**Subject:** PAP/2021/0663 - Land NE of M42 J10 - NH Response on Modelling and other Matters

### **Modelling Comments:**

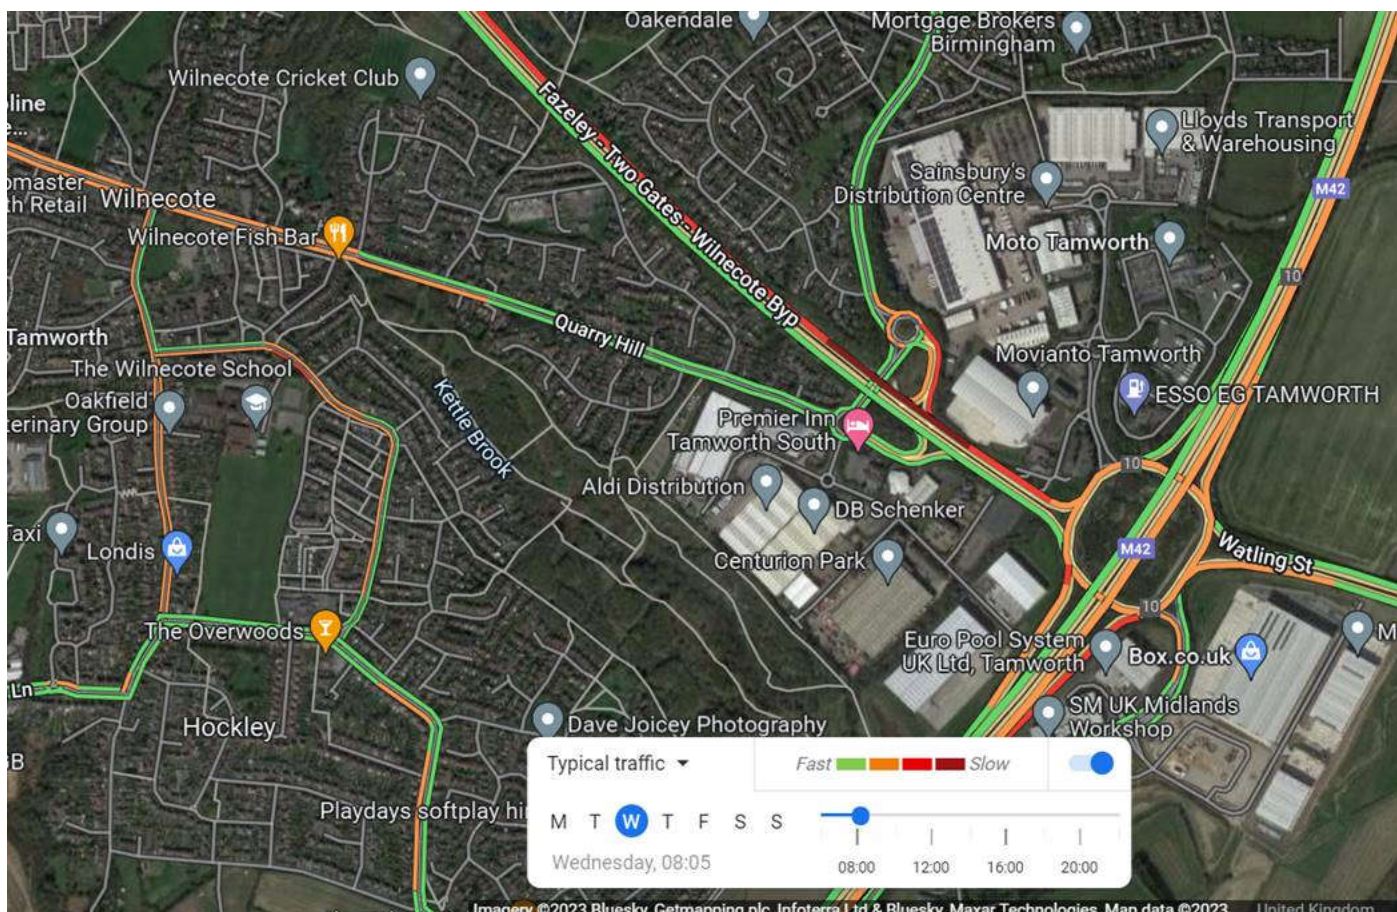
Furthermore, based on discussions with Staffordshire County Council (SCC), and our review the of the TRANSYT Model the junction of the A5 / Pennine Way has not been included in the assessments. This is an error and must be included within the assessment area. Queuing has regularly observed back from M42 J10 on the eastbound arm, queuing back to and often past the A5 / Pennine Way Junction during the peak periods. I have provided an image from google maps below for a typical traffic for a Wednesday at 8:00am.

Based on this, we agree with SCC that the Pennine Way Junction needs to be included with any modelling of the development site. We do recognise that information has been supplied to demonstrate that the queuing did not occur to this extent. However this was only taken on one day, and traffic levels and operations are still recovering from COVID. Therefore such a short period is not a robust submission to demonstrate the need to discount a junction.

Therefore in order to progress, based on the information provided and consideration of the information which has been provided by SCC and WCC we consider that the transport modelling needs to be revisited. In order to keep timescales it is recommended that the A5 Atherstone Model be utilised to assess the development impacts on the highway networks, and this is the most suitable tool as it includes the A5 / Pennine Way Junction.
